MEDIO CREEK WRC FILTER AND UV SYSTEM IMPROVEMENTS PROJECT

Solicitation Number: CO-00226

ADDENDUM 1

Date November 7, 2018

SHEET **S-03**
19 OF 67

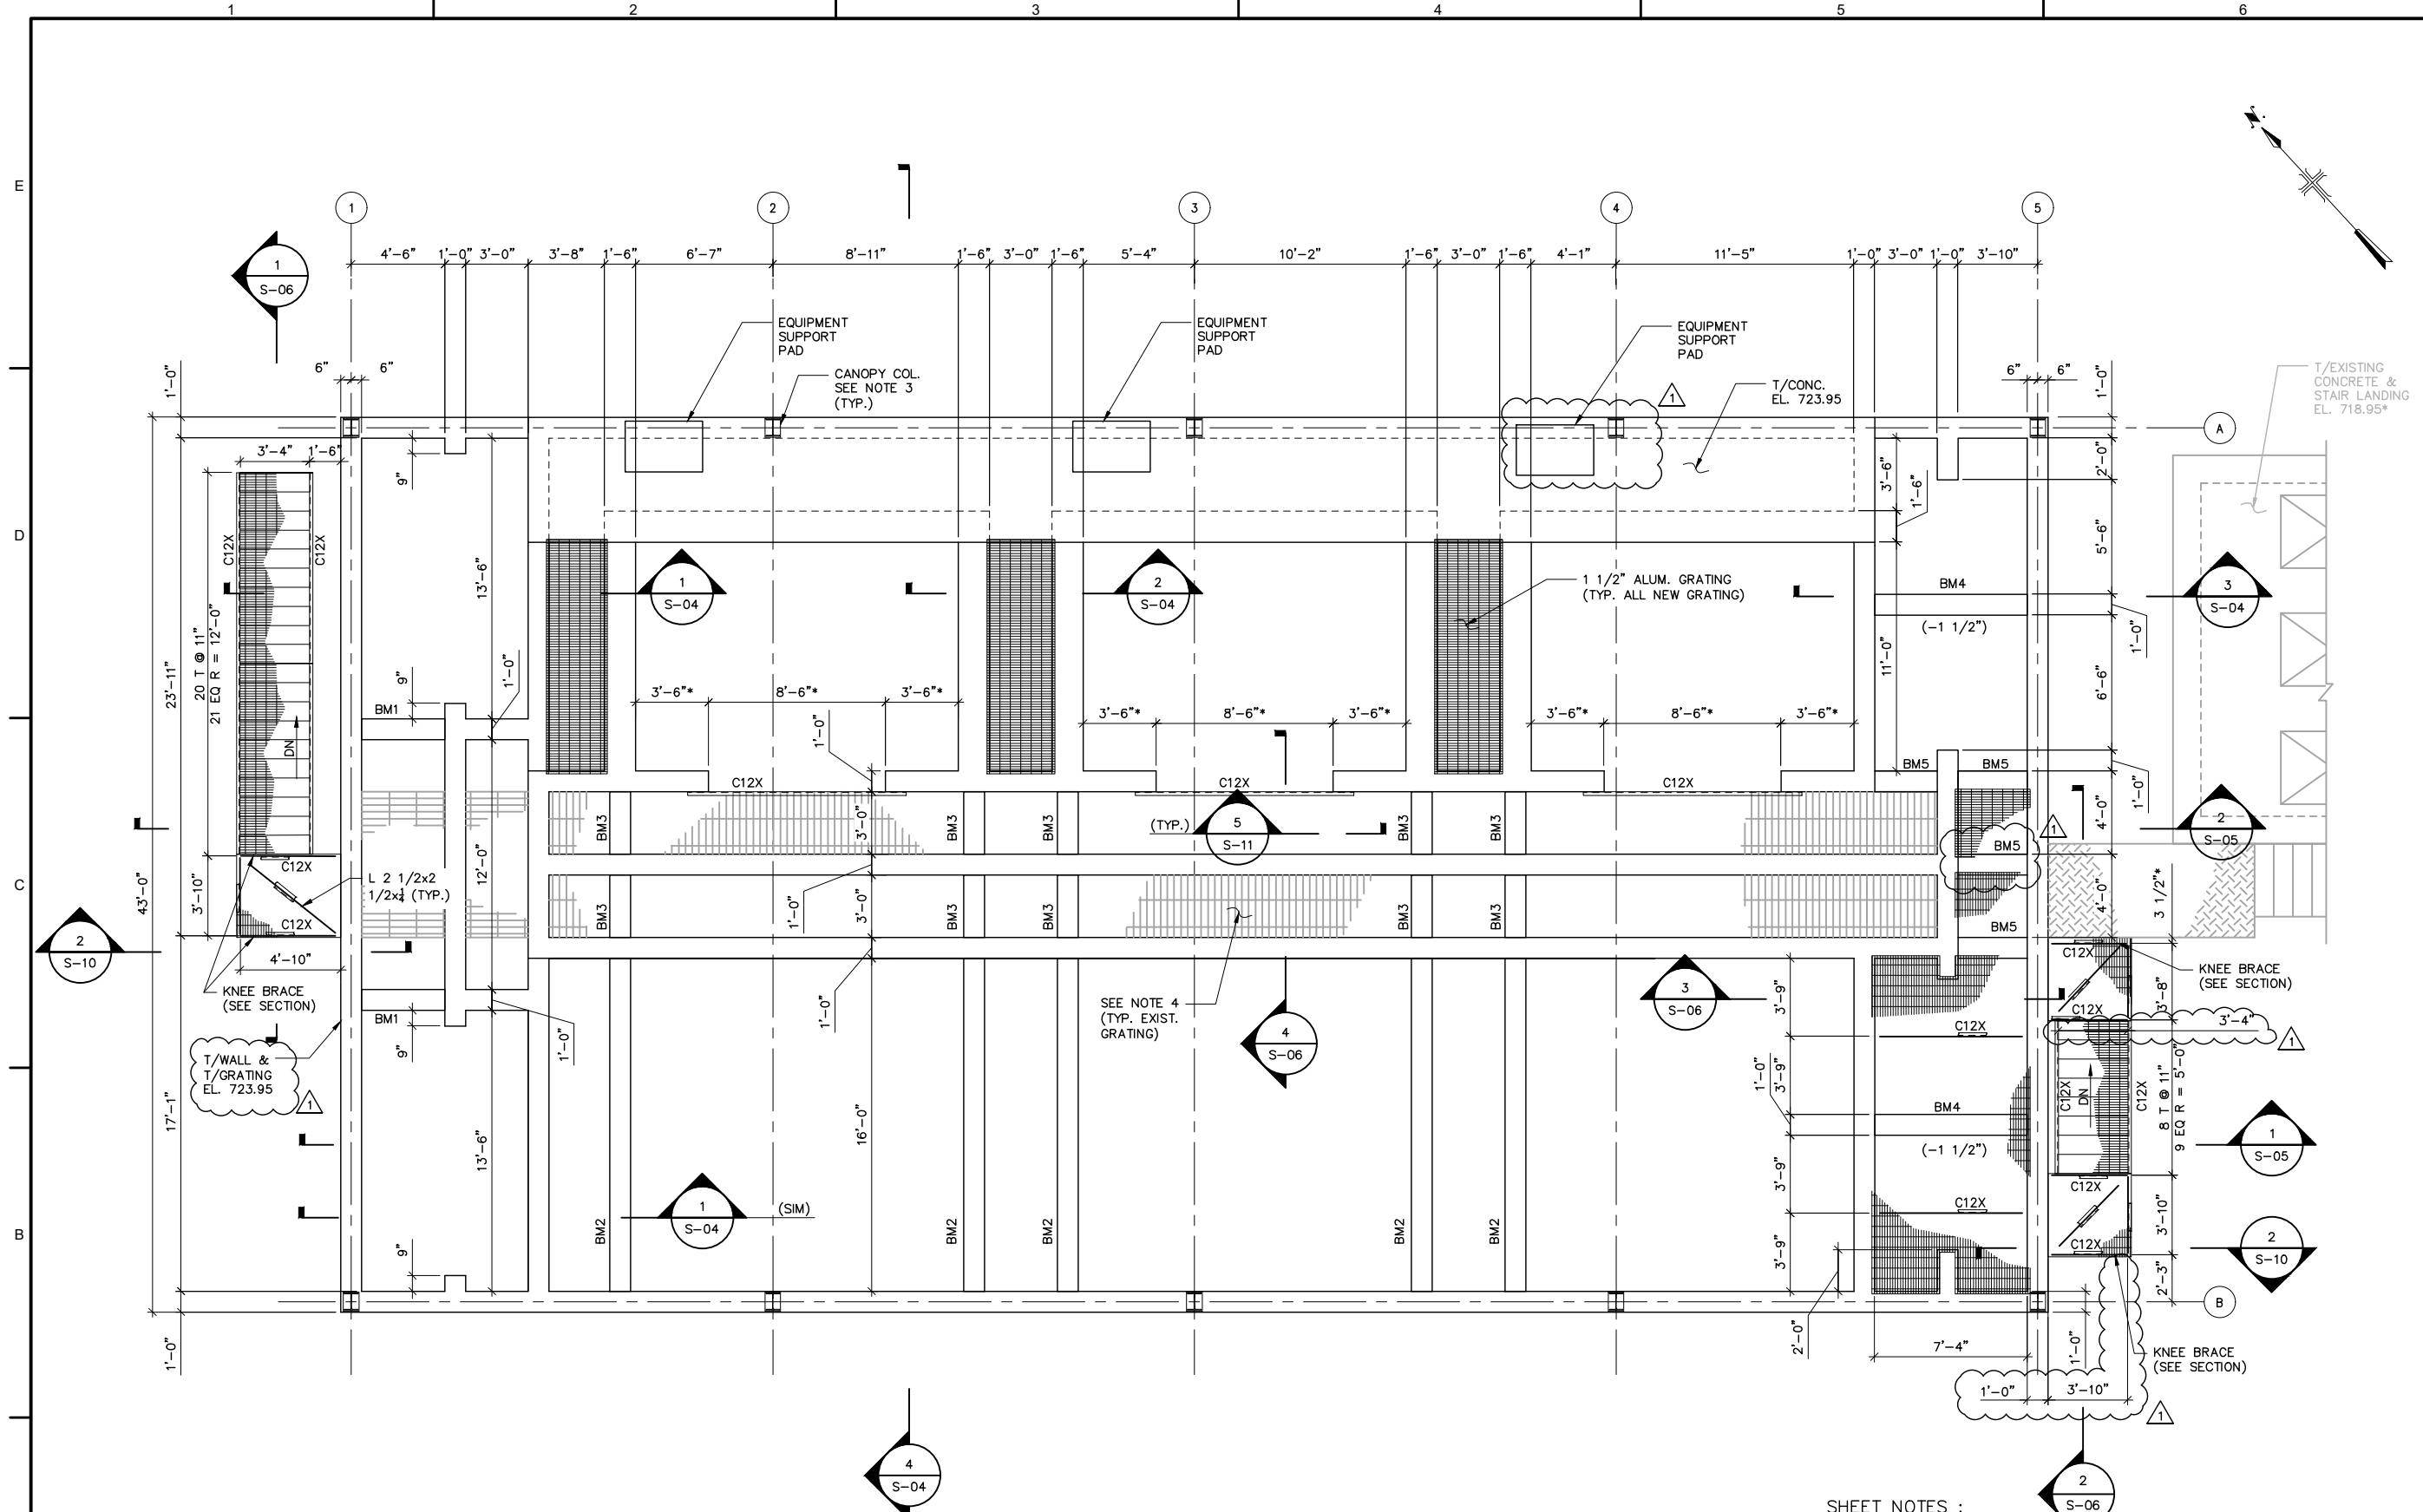
15. Sheet S-03, Replace the sheet with the attached.
 - a. Equipment support pad location adjusted and general sheet note 6 added.
16. Sheet S-04, Replace the sheet with the attached.

SHEET **S-04**
20 OF 67

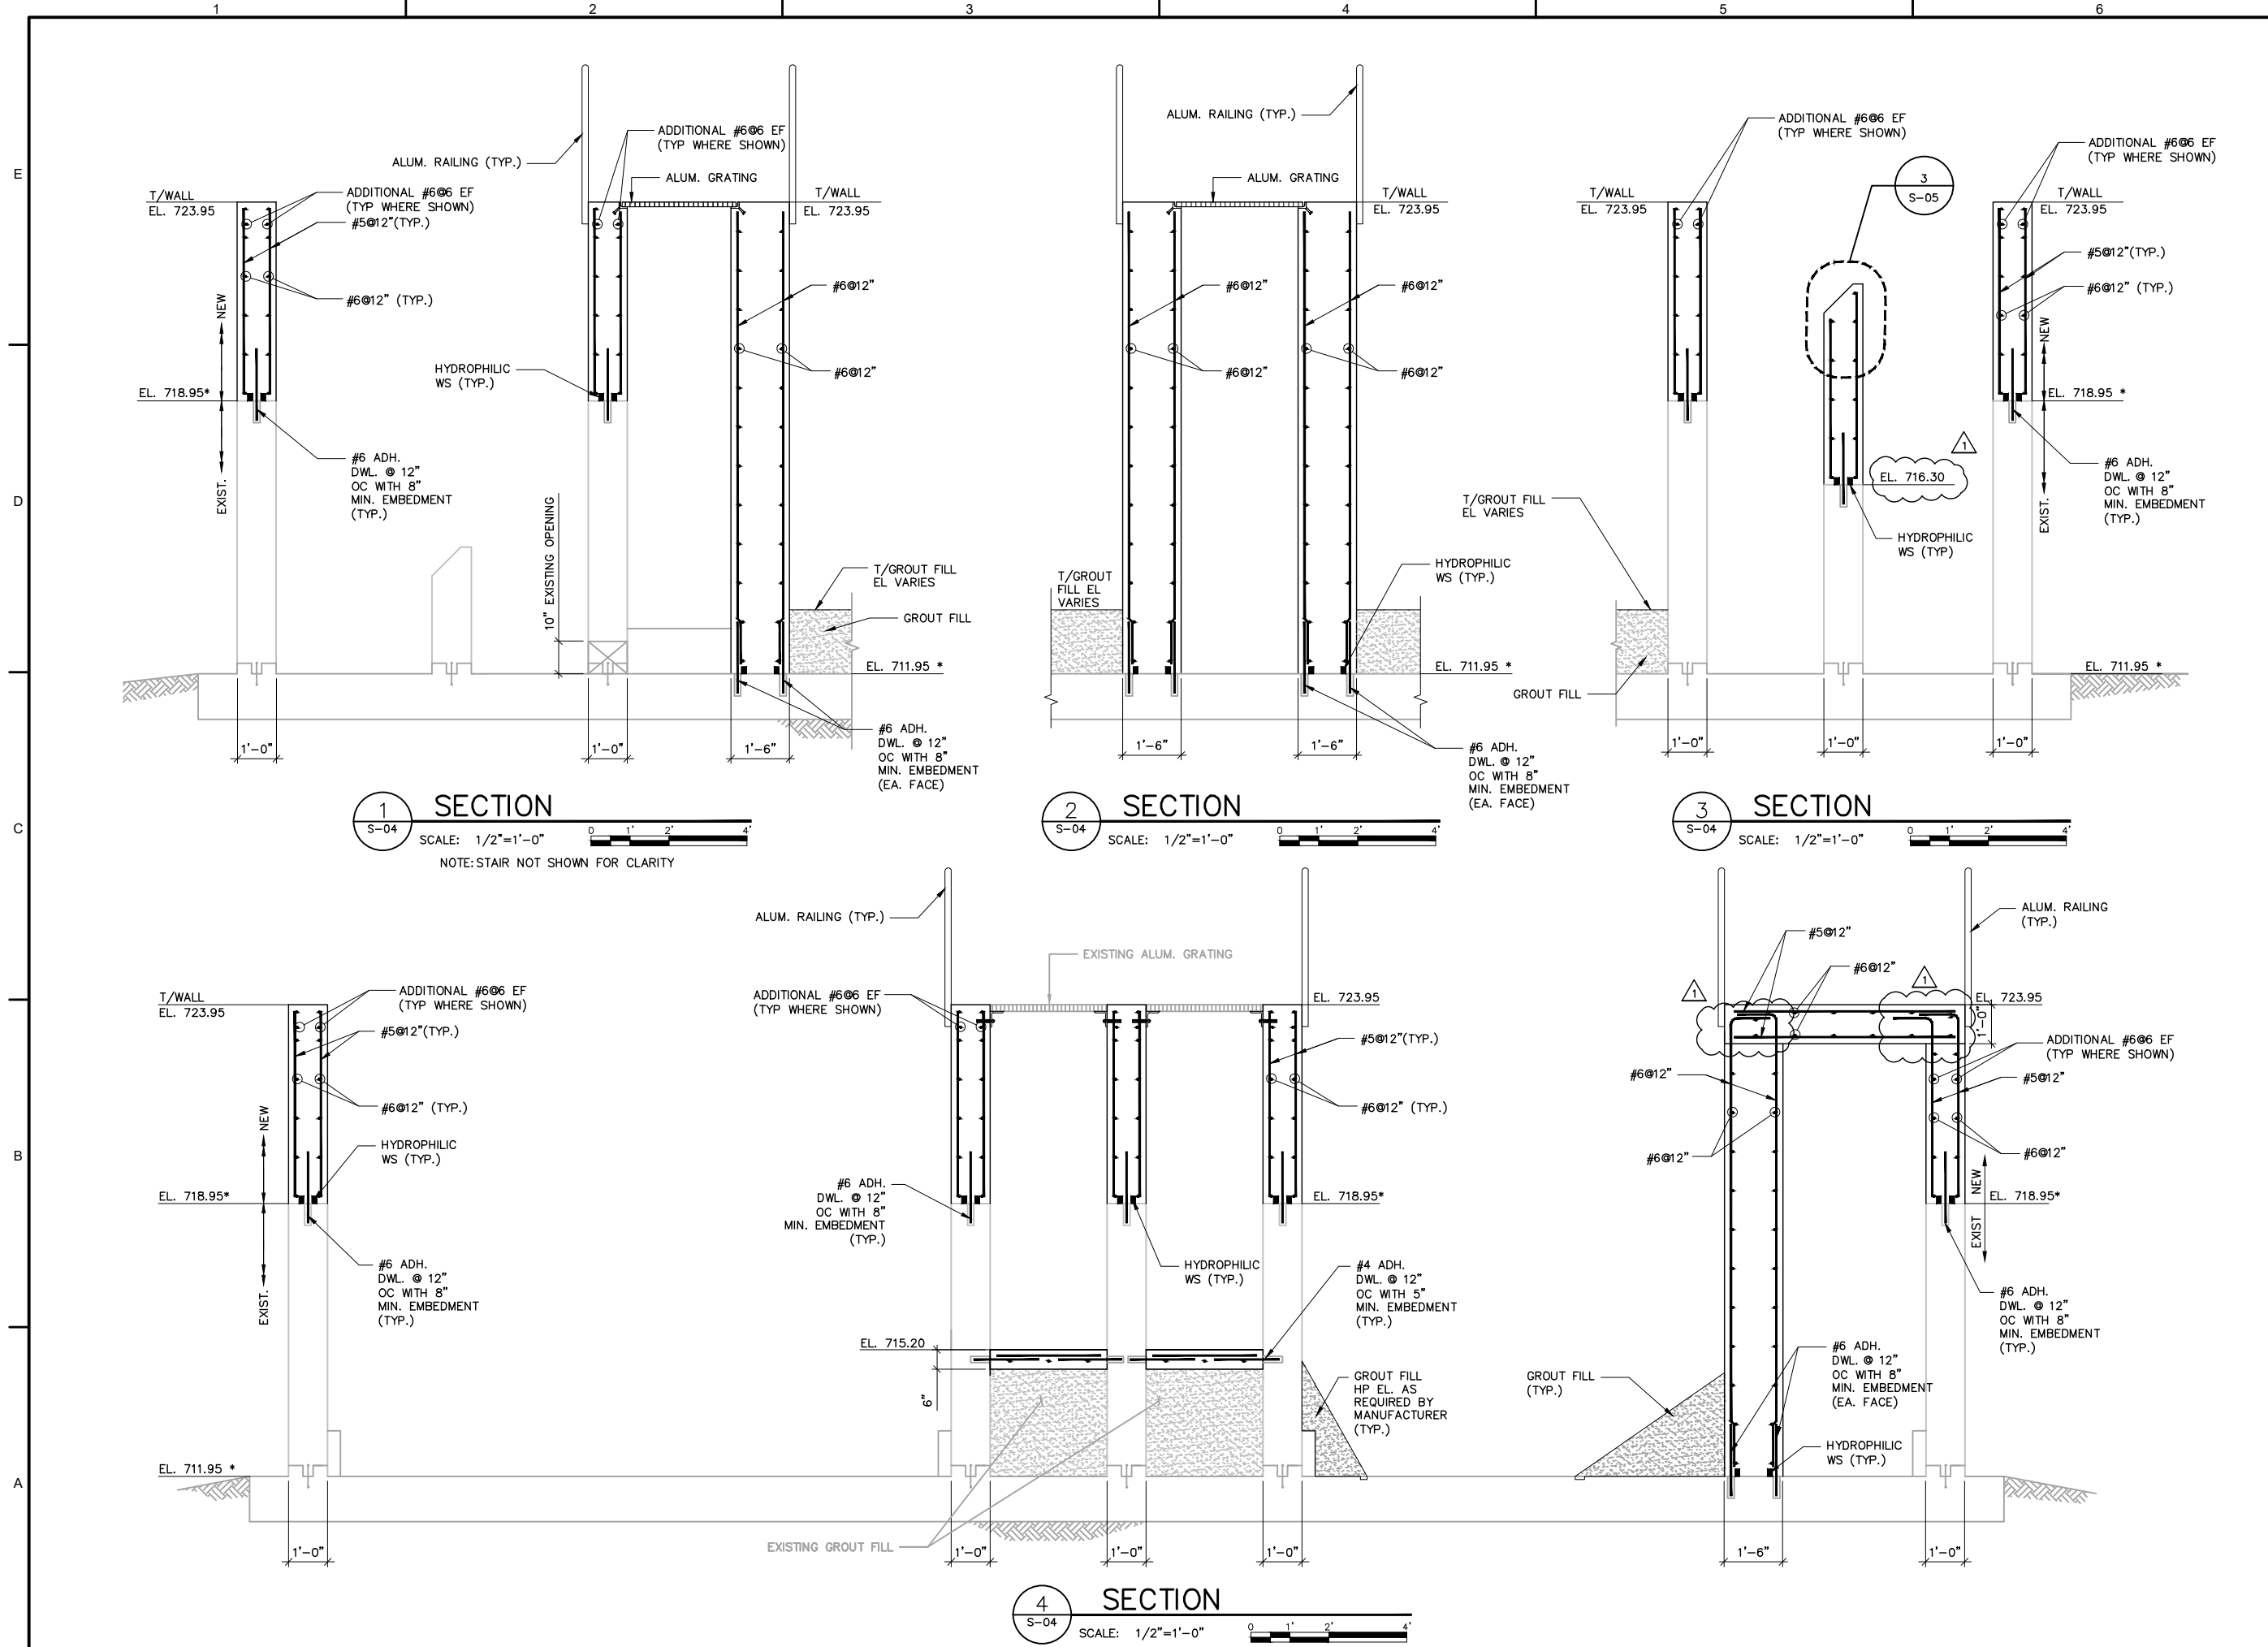
- a. Hooks added to reinforcing detail 4.
17. Sheet S-05, Replace the sheet with the attached.
 - a. Detail 1 updated expanding upon doweling information.

SHEET **S-06**

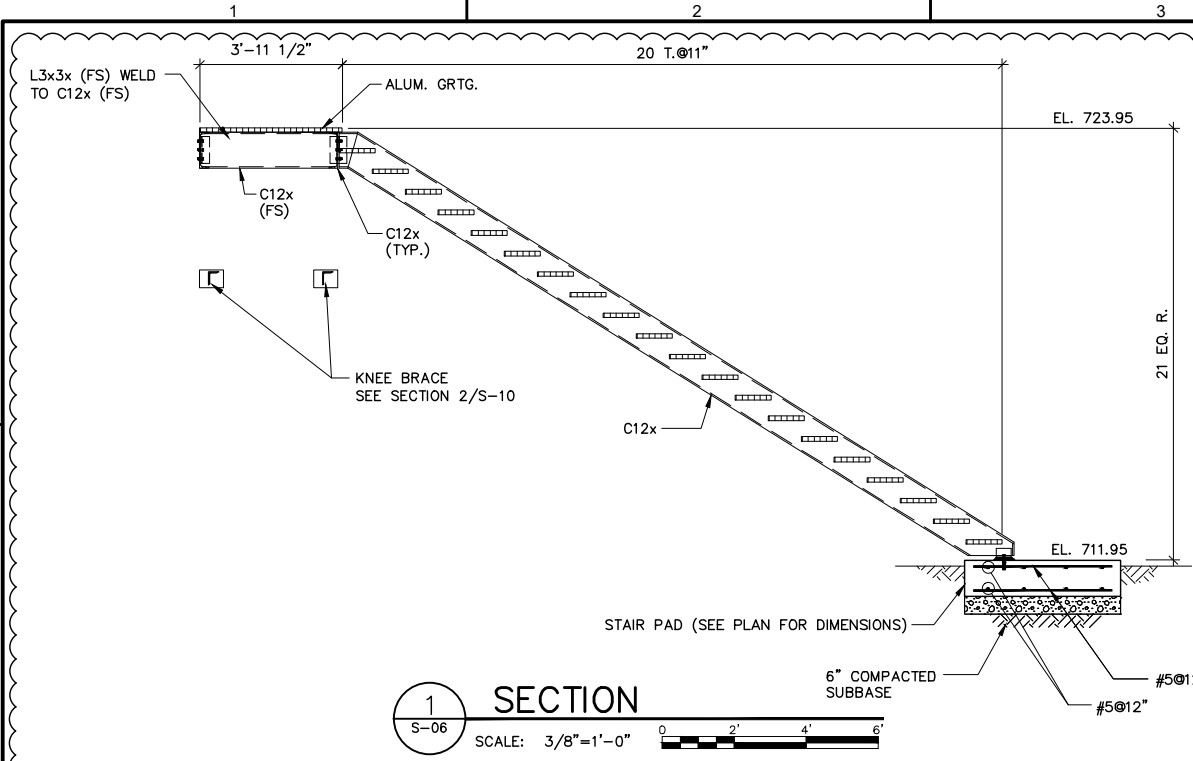
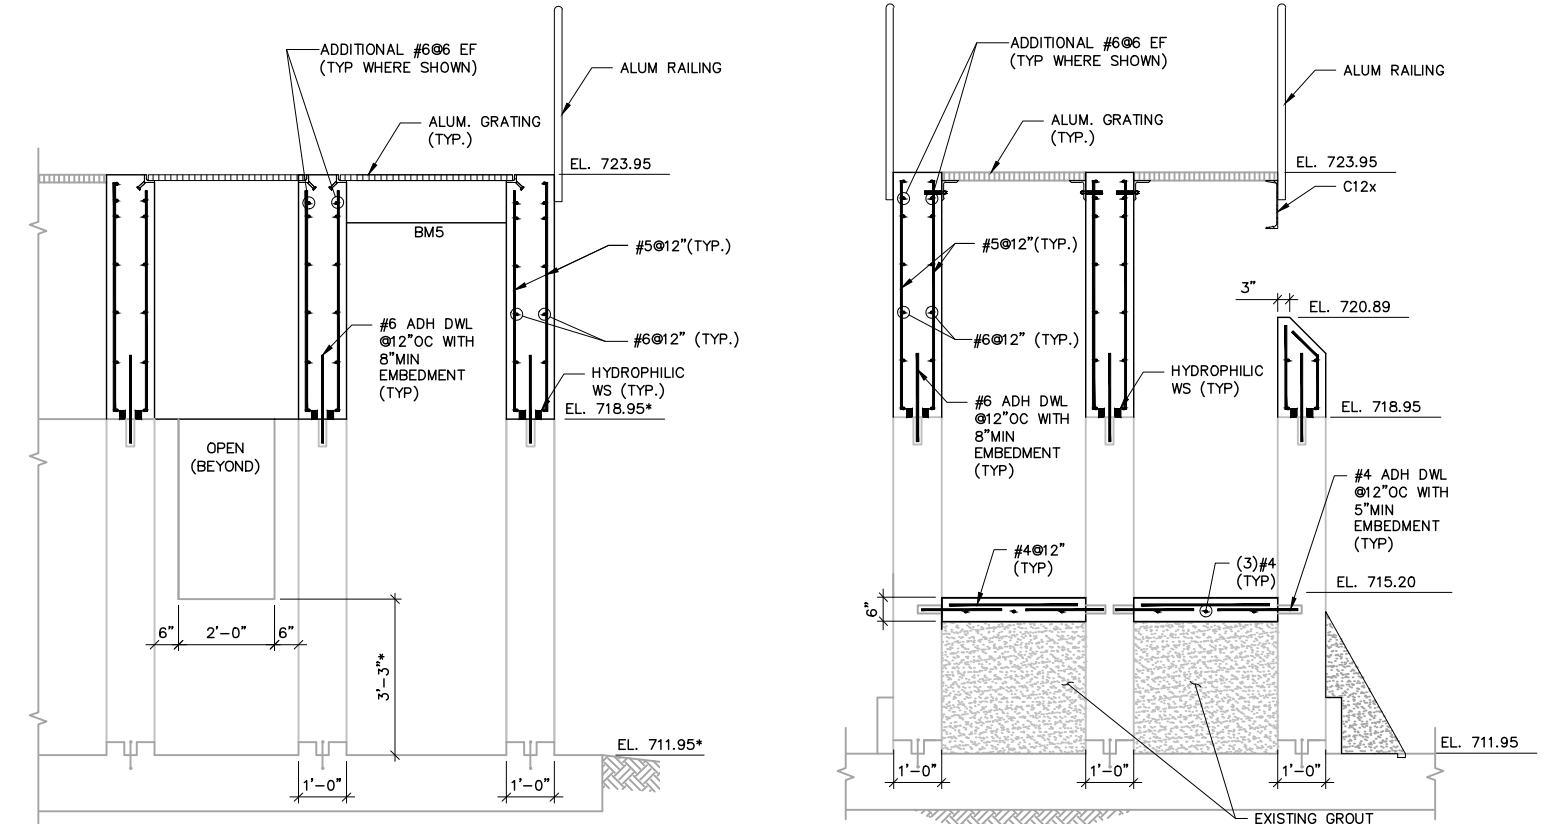
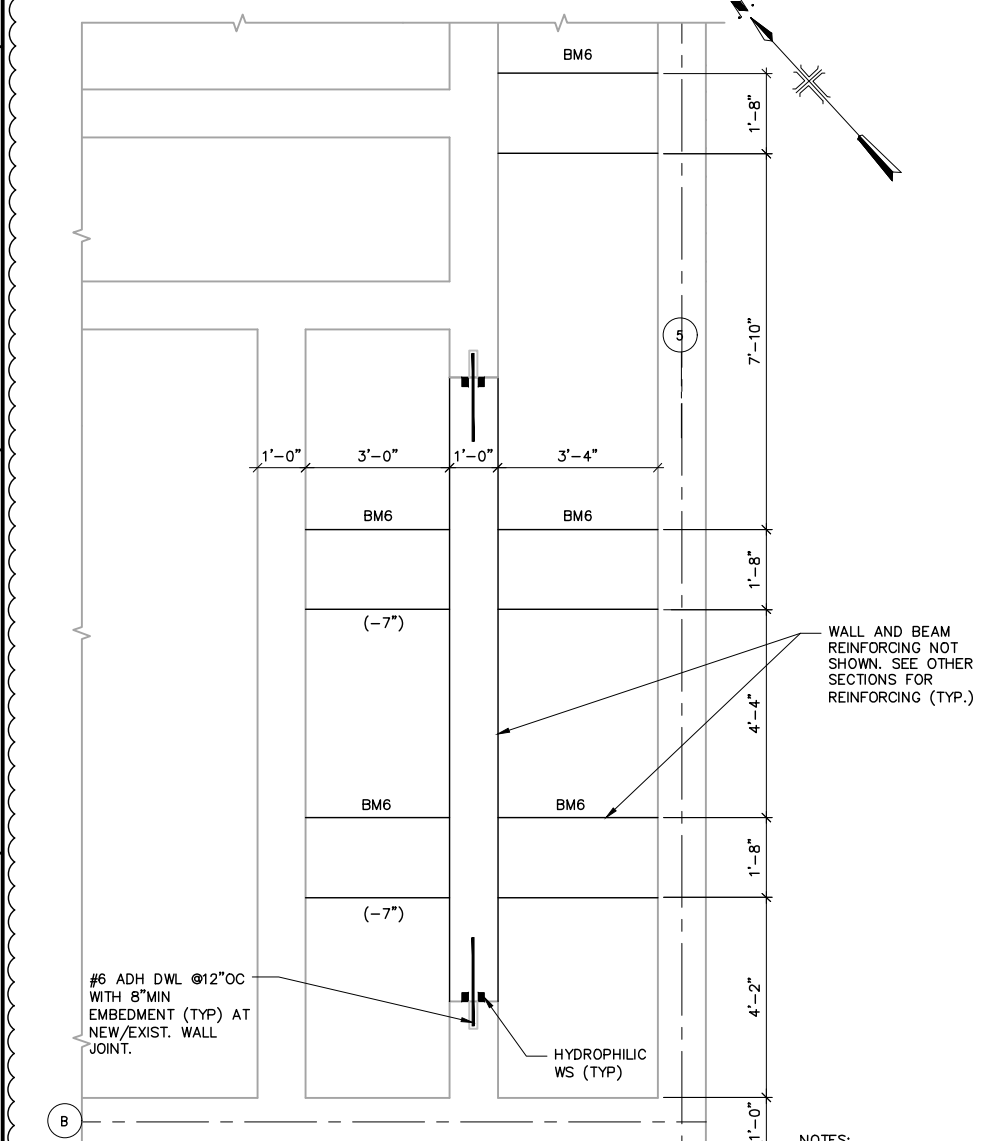
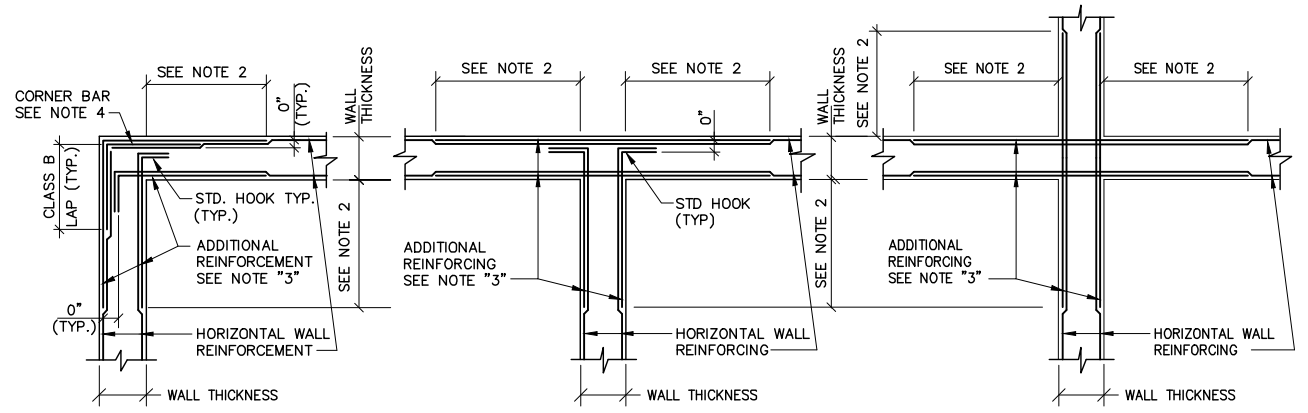
18. Sheet S-06, Replace the sheet with the attached.
 - a. Sheet rearranged and additional beam added.
19. Sheet S-08, Replace the sheet with the attached.
